WAYII AREA TRAIL DESIGN INDEX SHEET

--	----	----
--	----	----
--	----	----
--	----	----
1	REVISED REST AREAS	21/03/10
0	ISSUED FOR TENDER	21/02/18

TOFINO
**PACIFIC RIM
NATIONAL PARK RESERVE**
ʔapsčik tašii
(Ups-cheek ta-shee)
**“Going in the right
direction on the trail”**

WAYII AREA TRAIL DESIGN

TRAIL SECTIONS
STA 0+470 TO STA 0+490

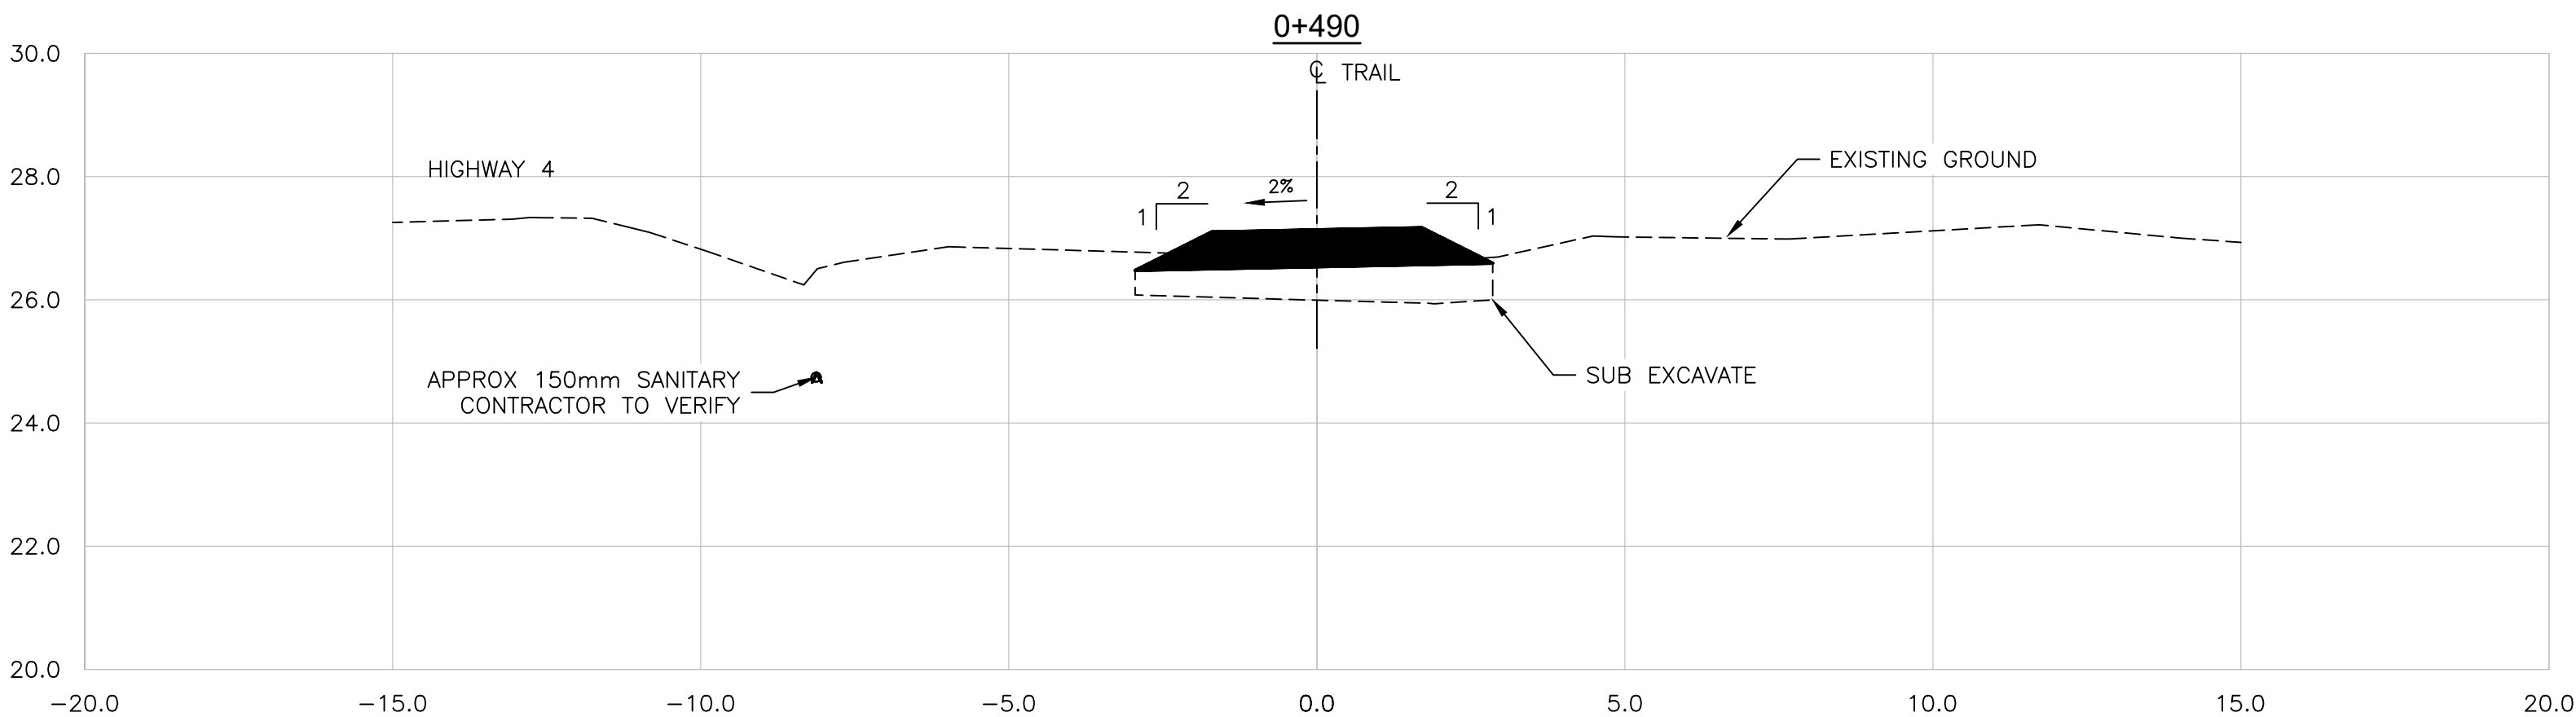
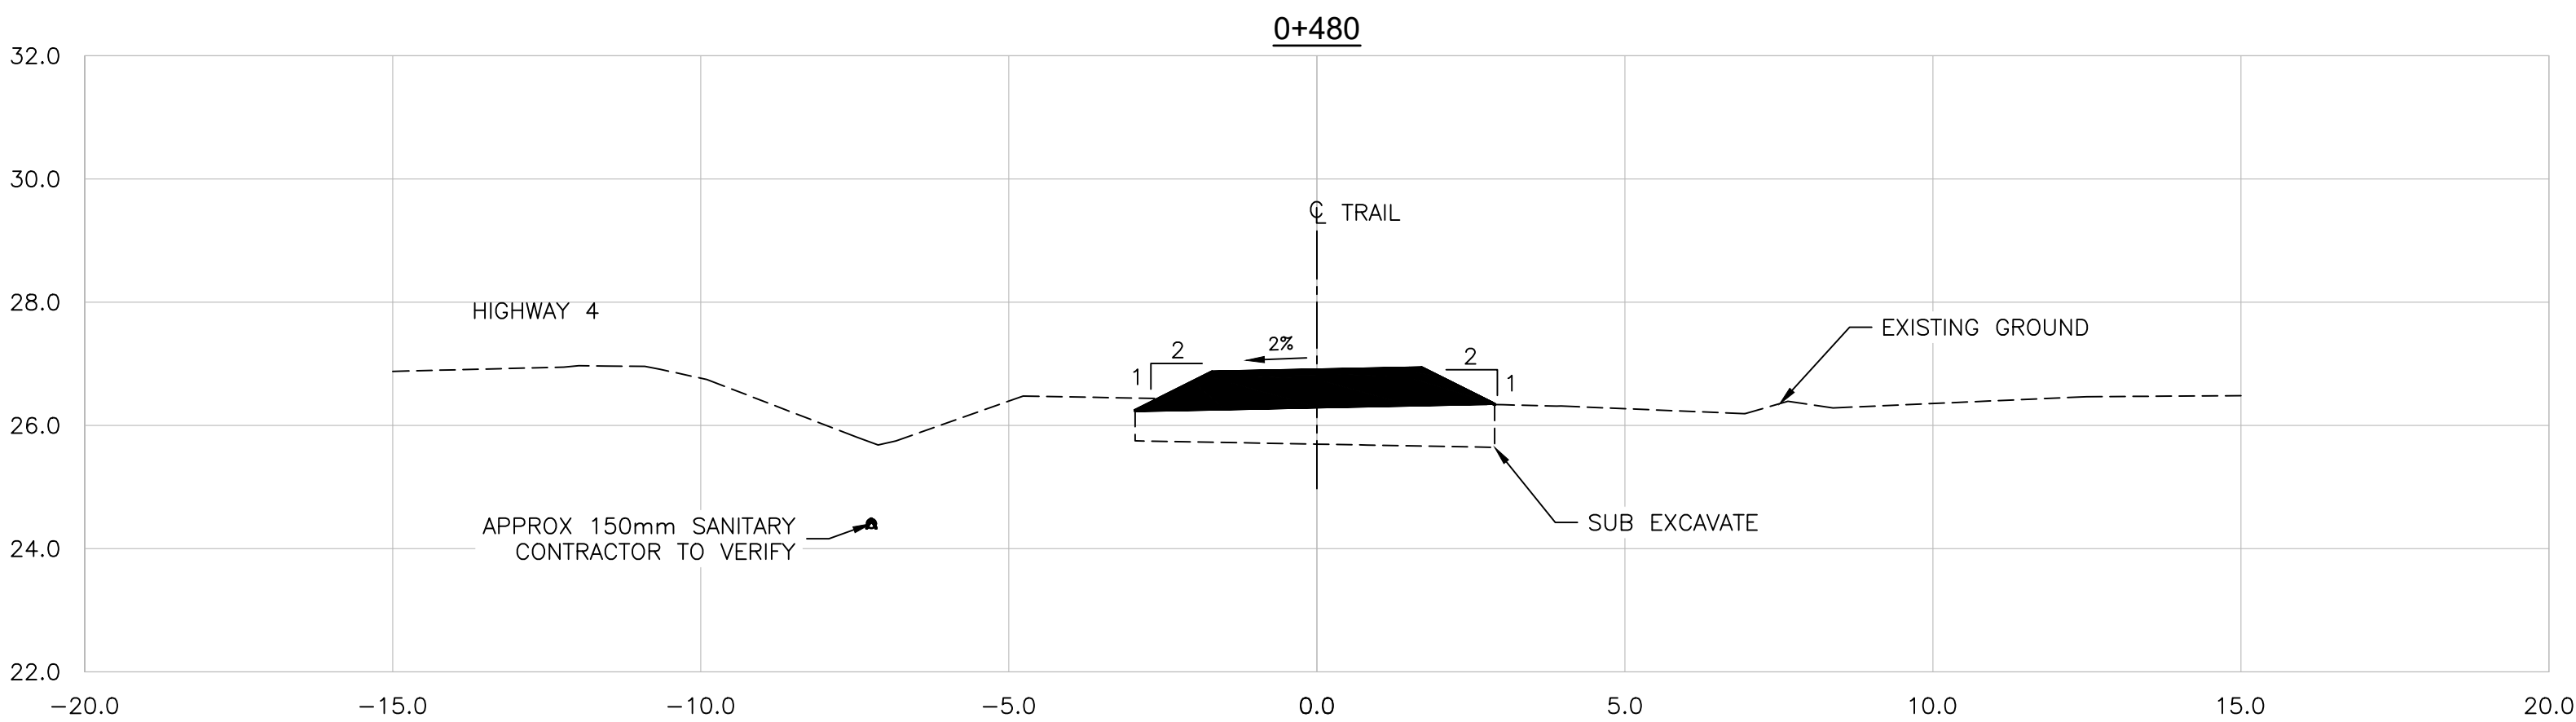
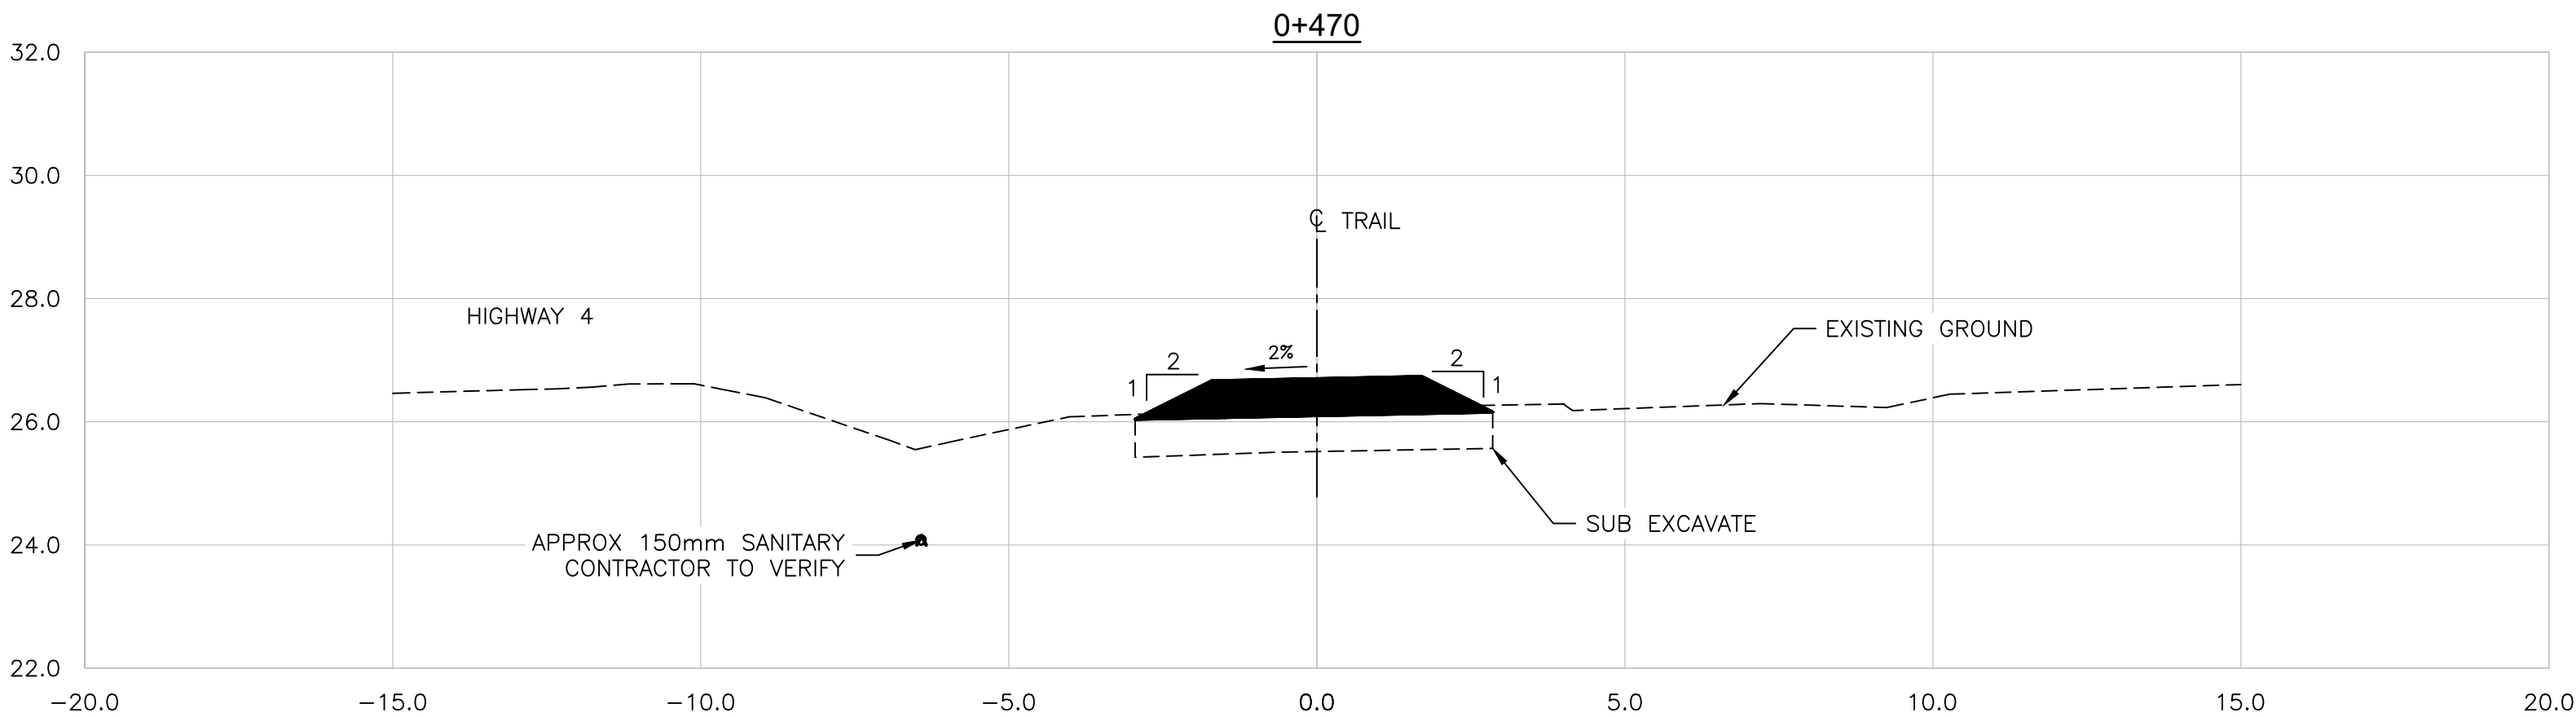
1
REVISED R1 AND
RELATED ADJUSTMENTS
TO TRAIL ALIGNMENT

WALL 1 & WALL 2
TYPICAL DETAIL - DOUBLE WALL AT 0+235

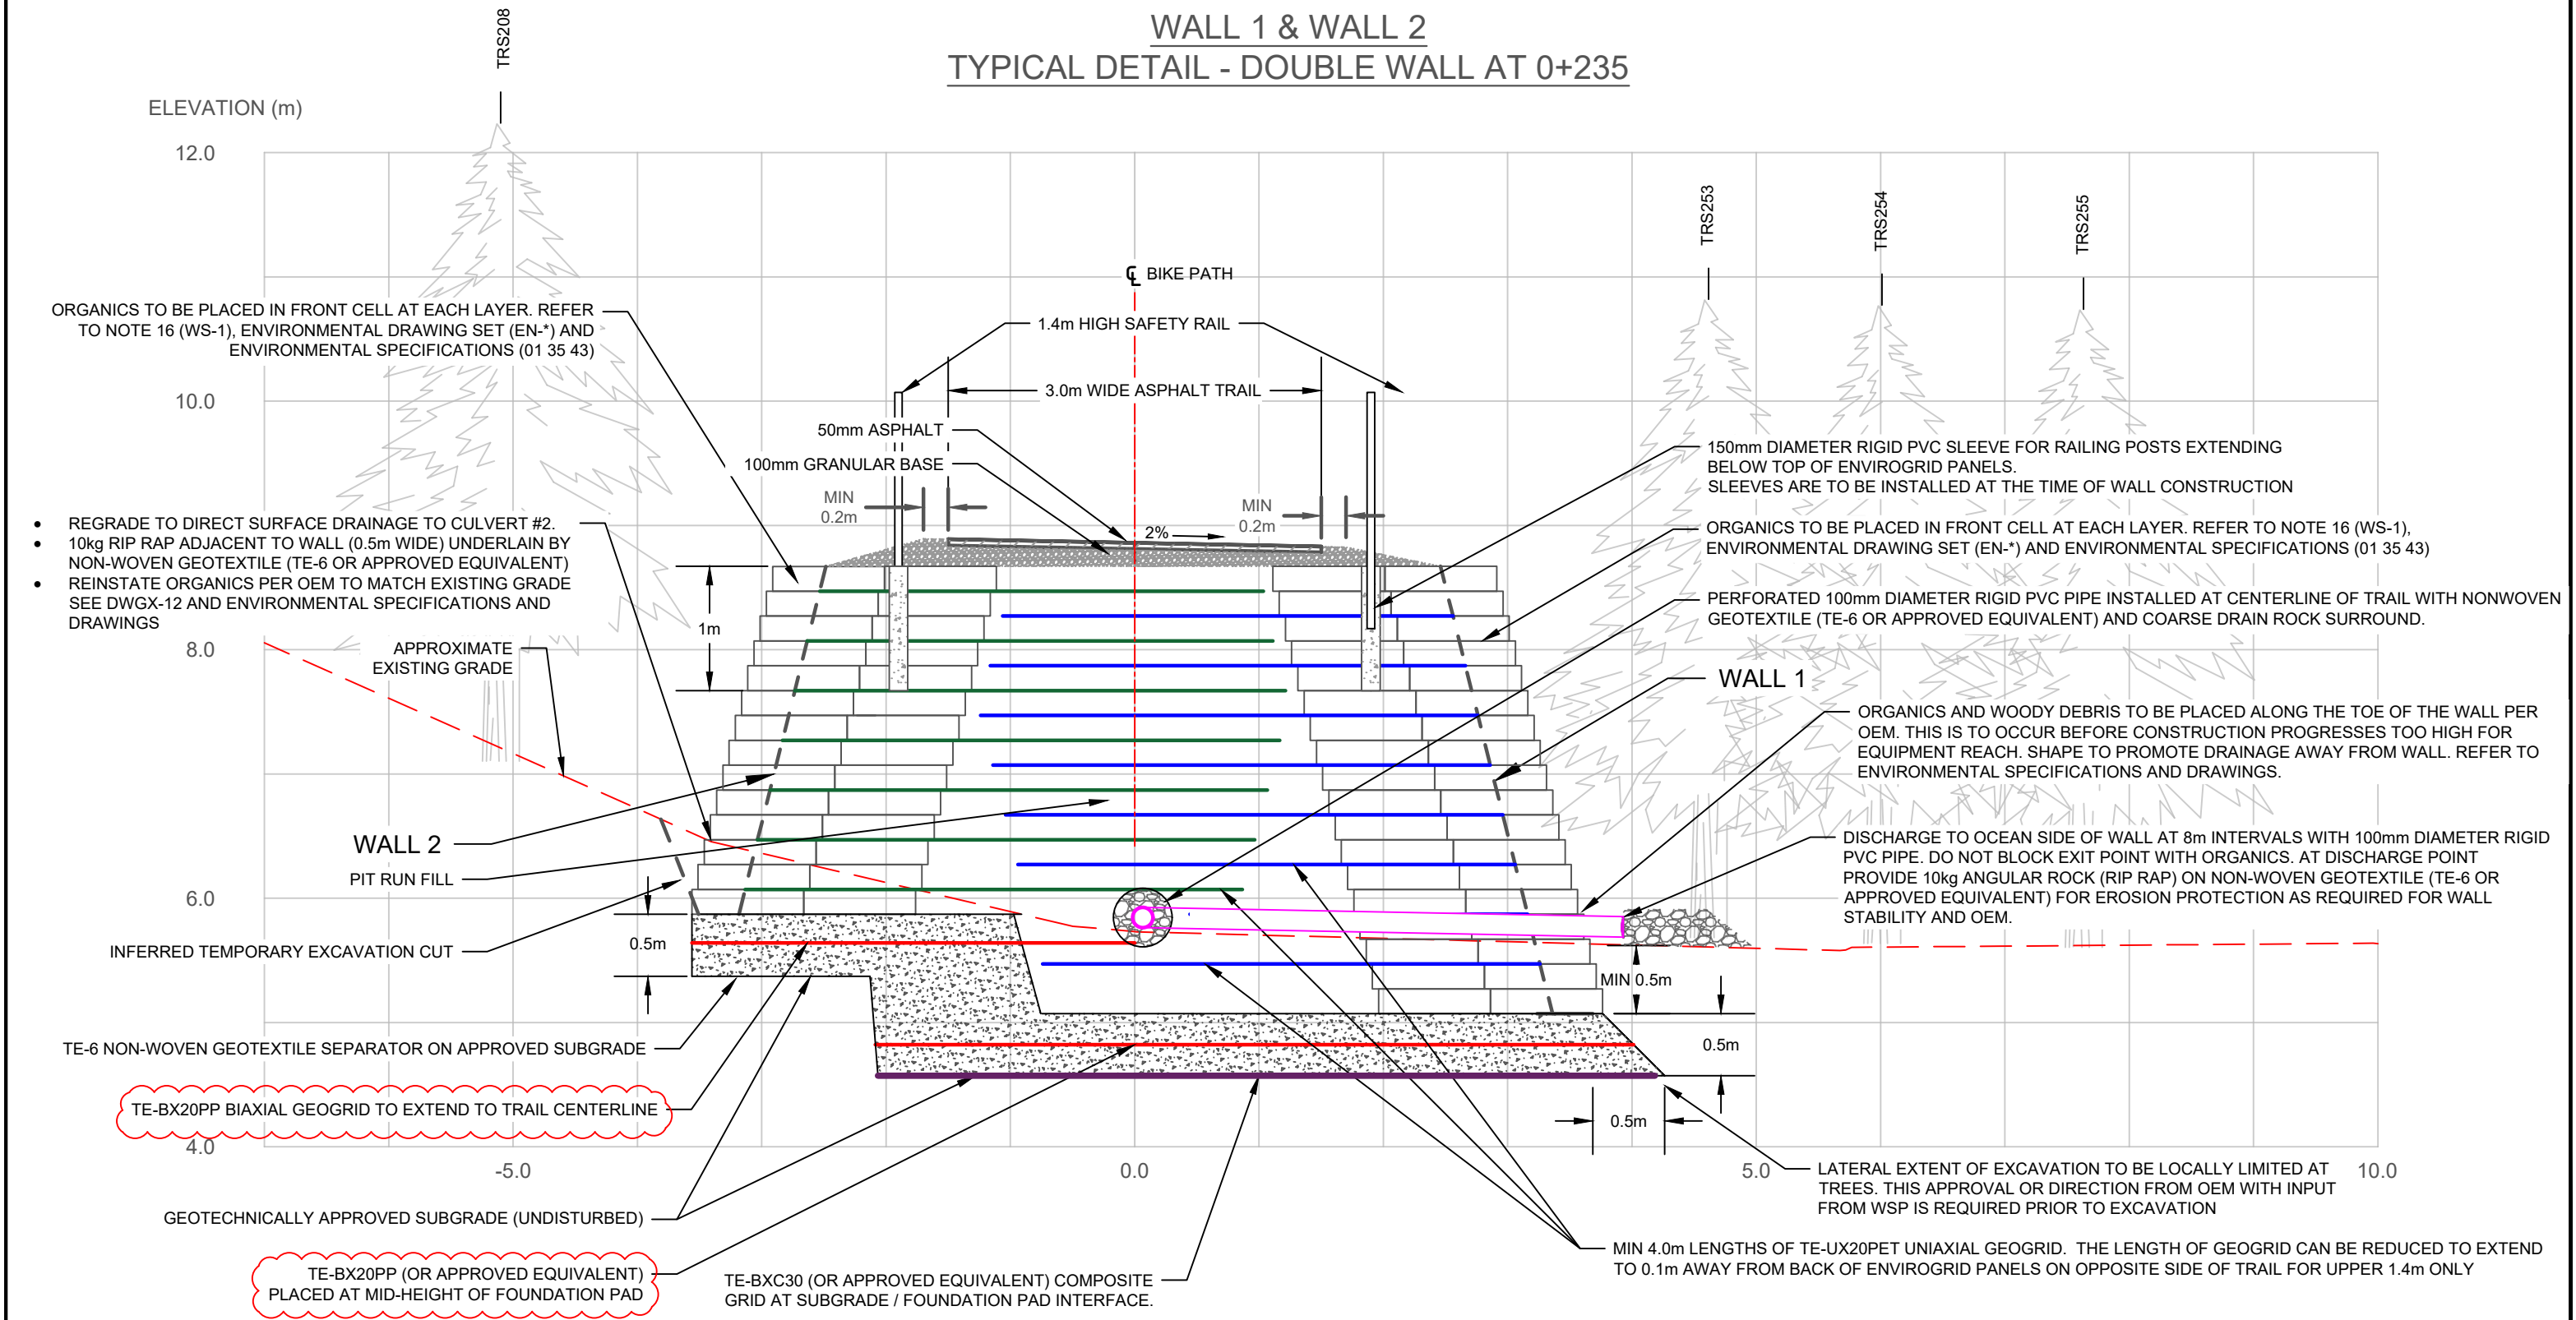
LEGEND:			PROJECT:		DATE:
			UPSCHEEK TASHEE MULTI-USE PATHWAY		FEB 2021
			WAYII AREA TRAIL DESIGN (ESCARPMENT)		DESIGN BY:
			PACIFIC RIM NATIONAL PARK RESERVE, TOFINO, BC		DF
			CLIENT:		DRAWN BY:
1	BI-AXIAL GEOGRID REF	03/12/21	PARKS CANADA		BPK
0	ISSUED FOR TENDER	02/17/21	TITLE:		CHECKED BY:
			WALL 1 & 2 DETAIL (STATION 0+235)		DF
REV. :	DESCRIPTION:	DATE :	SCALE:		PROJECT No.:
		(M/D/YR)	AS SHOWN		191-08875-02
			THIS DRAWING IS THE SOLE PROPERTY OF WSP CANADA INC. AND CANNOT BE USED OR DUPLICATED IN ANY WAY WITHOUT THE EXPRESSED WRITTEN CONSENT OF WSP. THE GENERAL CONTRACTOR SHALL VERIFY ALL DIMENSIONS AND REPORT ANY DISCREPANCIES OR OMISSIONS TO WSP.		FIGURE NO.:
					WD-2
